**Lannan Road Development (the site)
For Zoning Amendment Bylaw No. 2973**

Preliminary Stormwater Management Master Plan (PSMMP)

**Re: Lannan Road Development (the site) for Zoning Amendment Bylaw No. 2973
 Preliminary Stormwater Management Master Plan (PSMMP), Revision 2**

**City Memorandum dated March 14, 2025
Review of January 23, 2025 Master Plan Resubmissions**

FIGURE 5

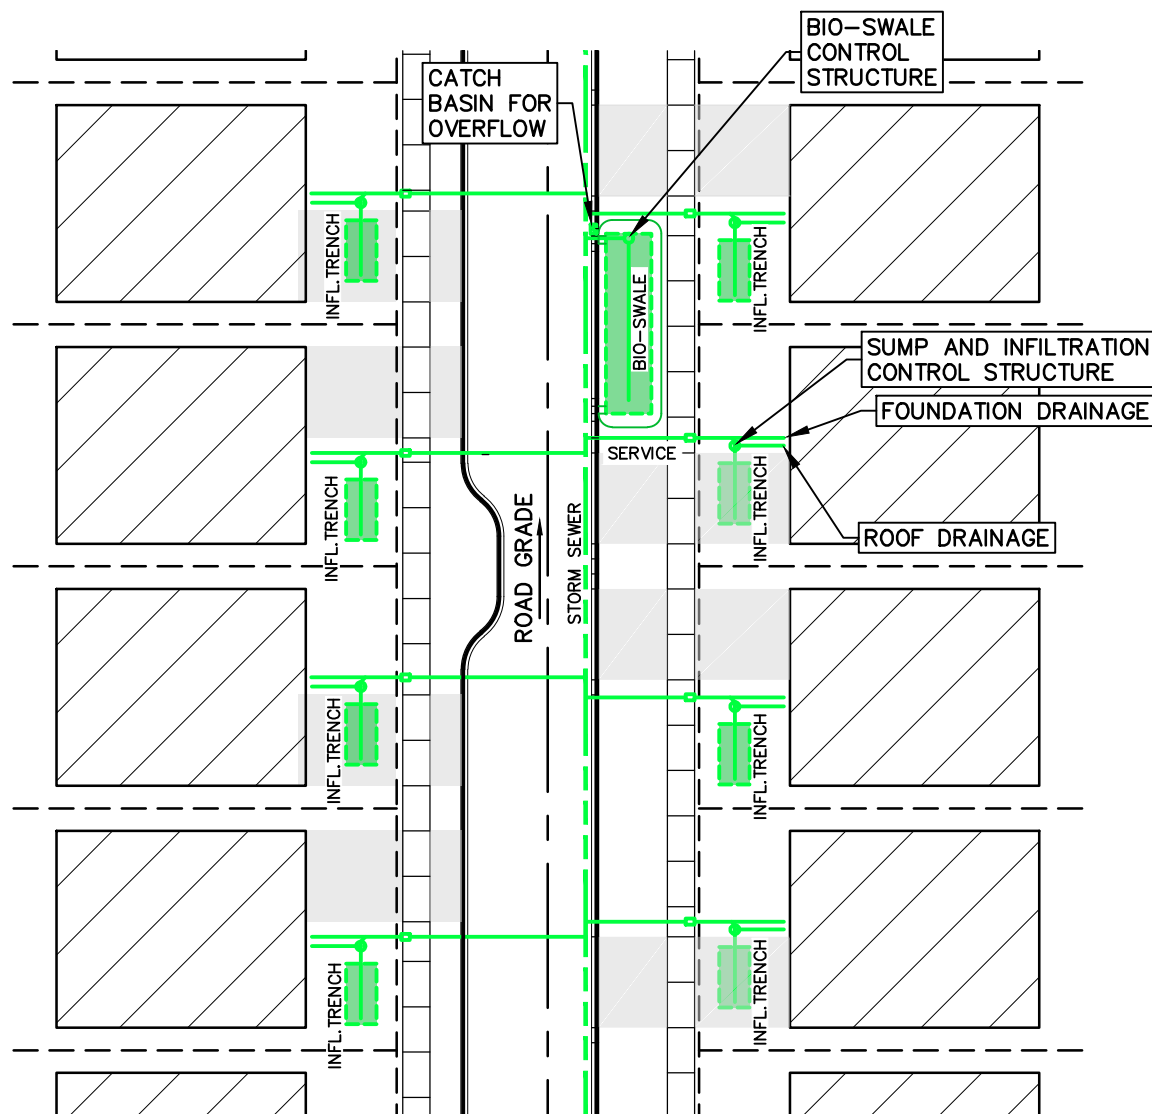
33. Table 8 assumes an infiltration rate of 10mm / hr, author needs to speak to options if that rate cannot be obtained. What are these options
 34. Figure 5 - Onsite infiltration trenches can be effective when maintained, how will the City ensure the property owners maintain they're on site stormwater facilities and not simply let them overflow to the road if they become plugged or clogged? A covenant will be required for the lots. A lot grading plan will be required to identify locations ad provide a maintenance document.

- Item 34) See the response above to items 29, 30, and 33. Each private onsite infiltration trench will have an overflow connection to the municipal storm drainage system. Lot grading plans will be developed during the detailed design phase. Maintenance documentation can be developed during the detailed design phase.

DRAWING No.	REV.	SHEET
FIGURE 6	2	1/1

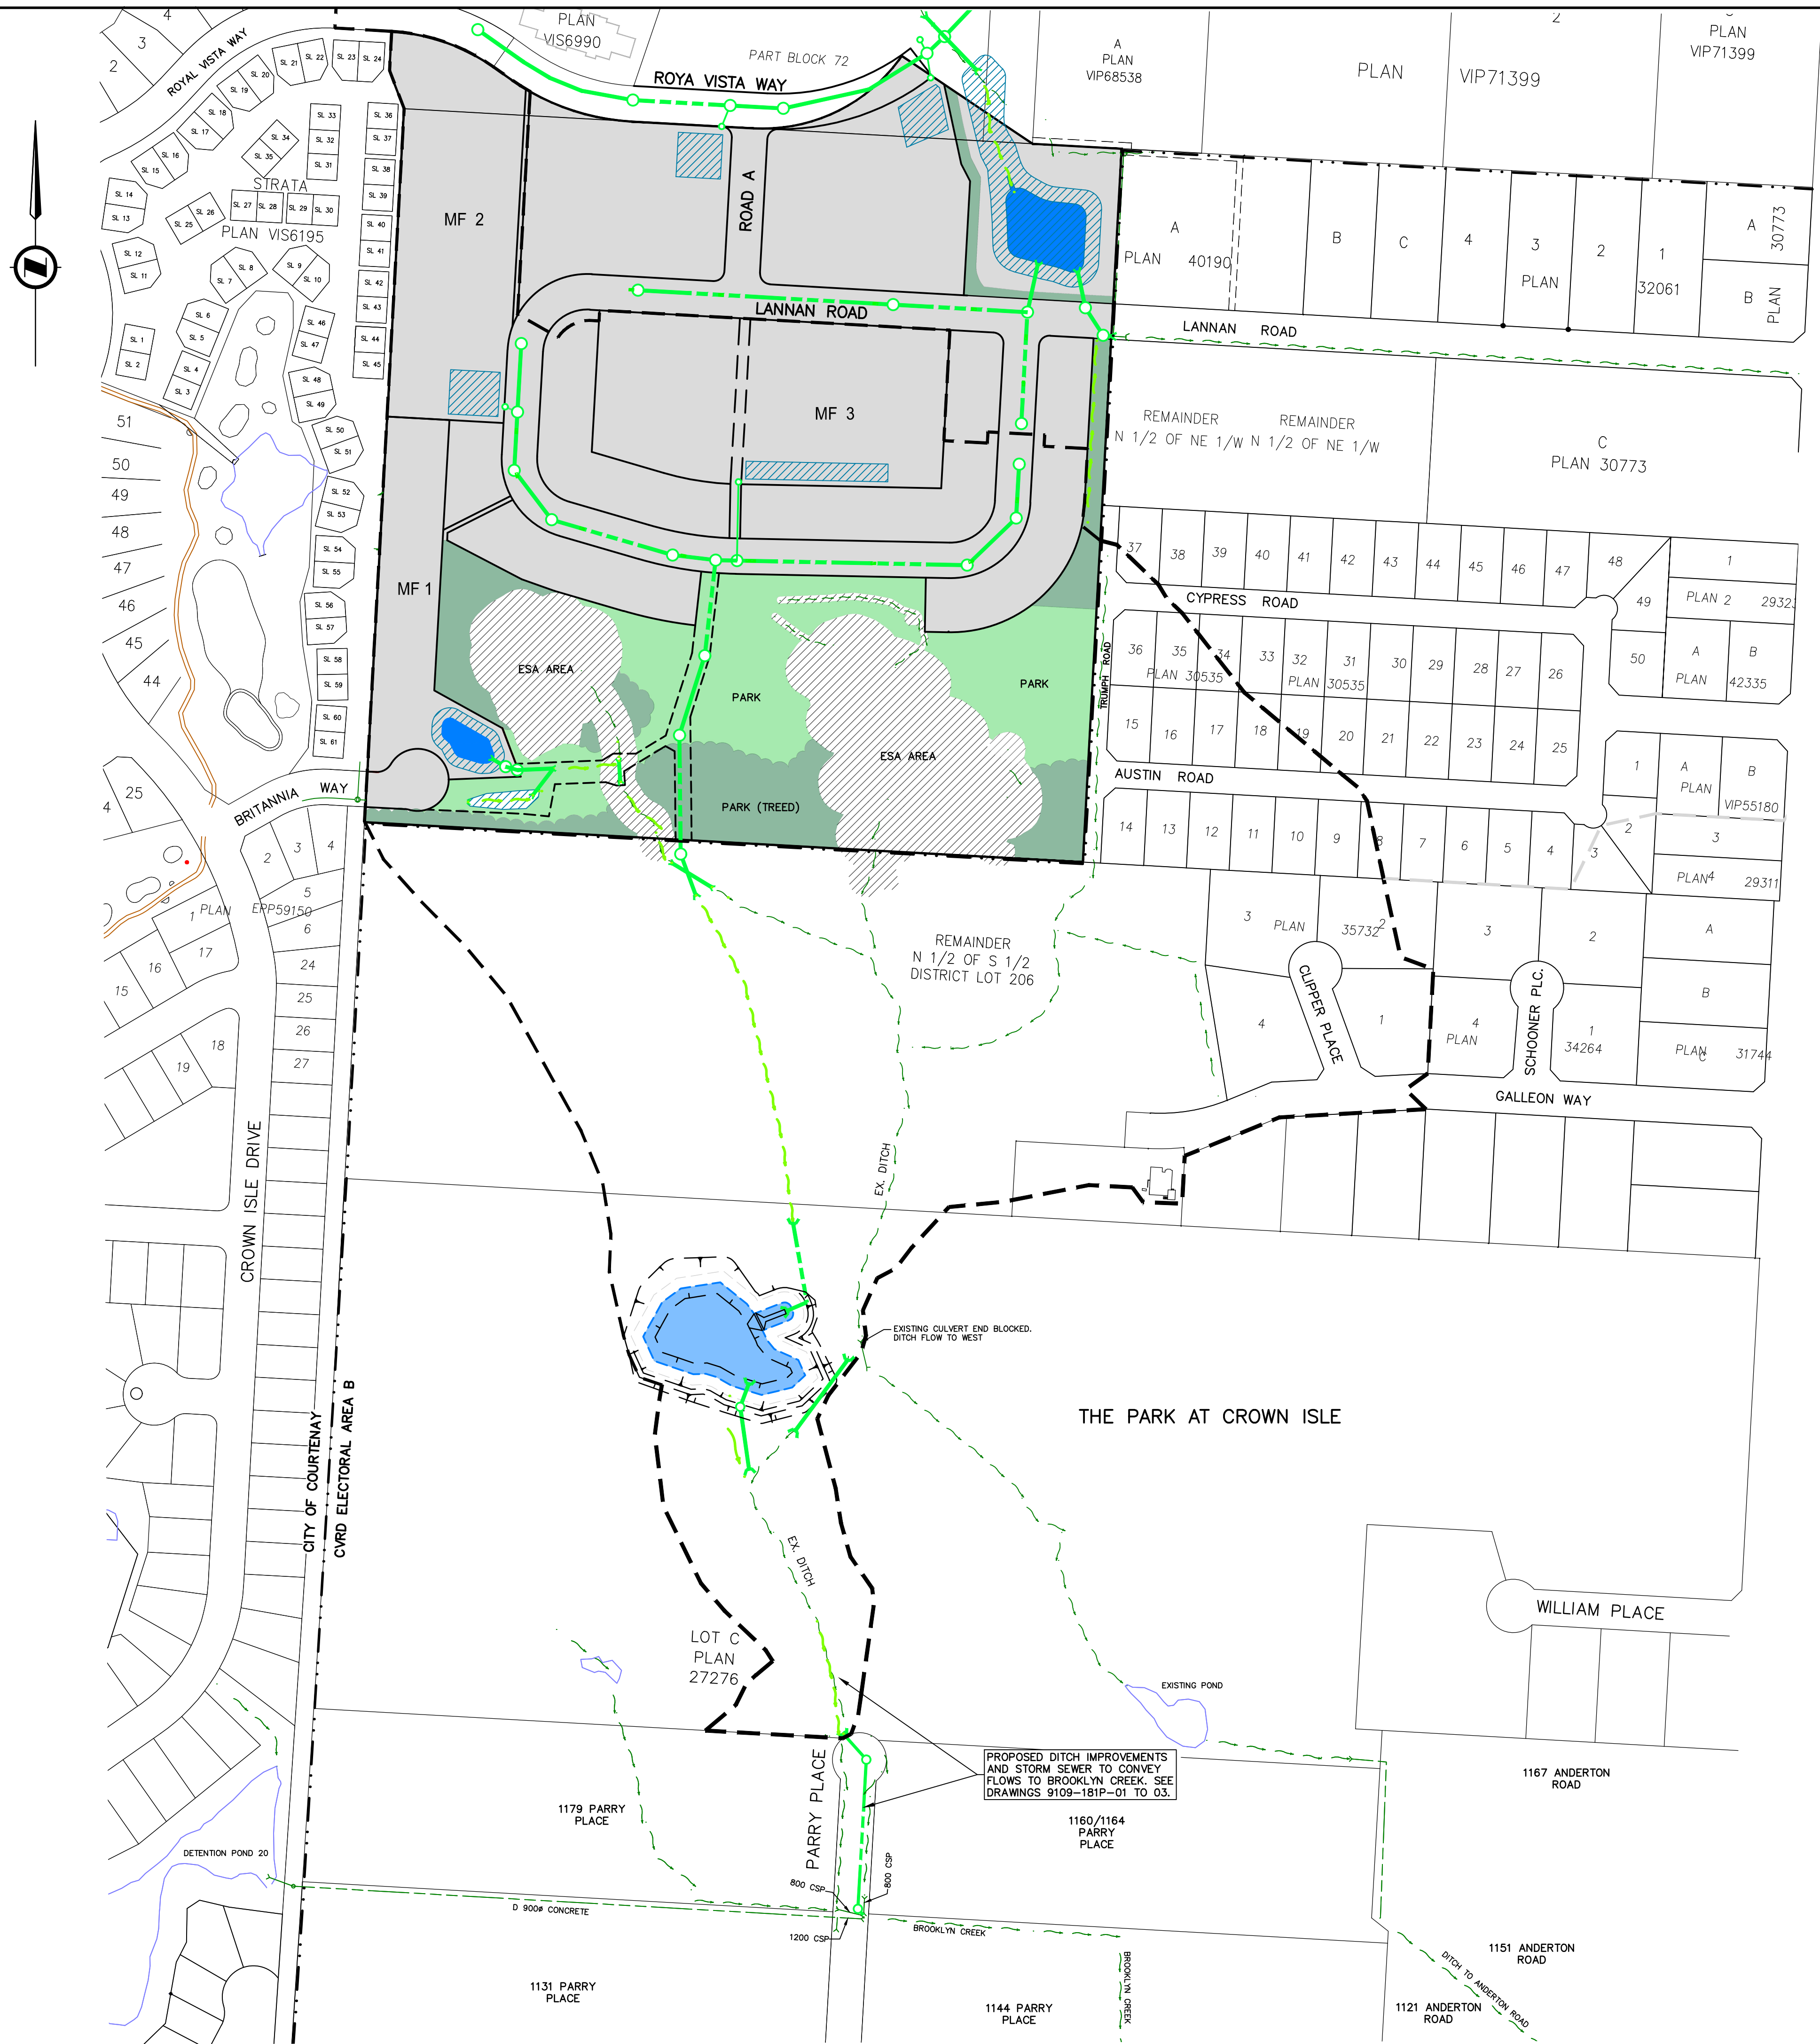
1. This area is outside our municipal boundary, require an SRW/Easement to maintain this infrastructure
 2. Has it been demonstrated that the existing ditches have the capacity to carry the 2024-06-05100-year flow path? Verify that the culverts in this ditch are sized for this, and will not cause flooding to private property along Parry Place.

- Item 21ii) The applicant has agreed to register SRW's over the proposed storm drainage works that will be located on private property at 2205 Galleon Way and 1239 Anderton. *Note – a property with the address 2205 Parry Place does not exist.*
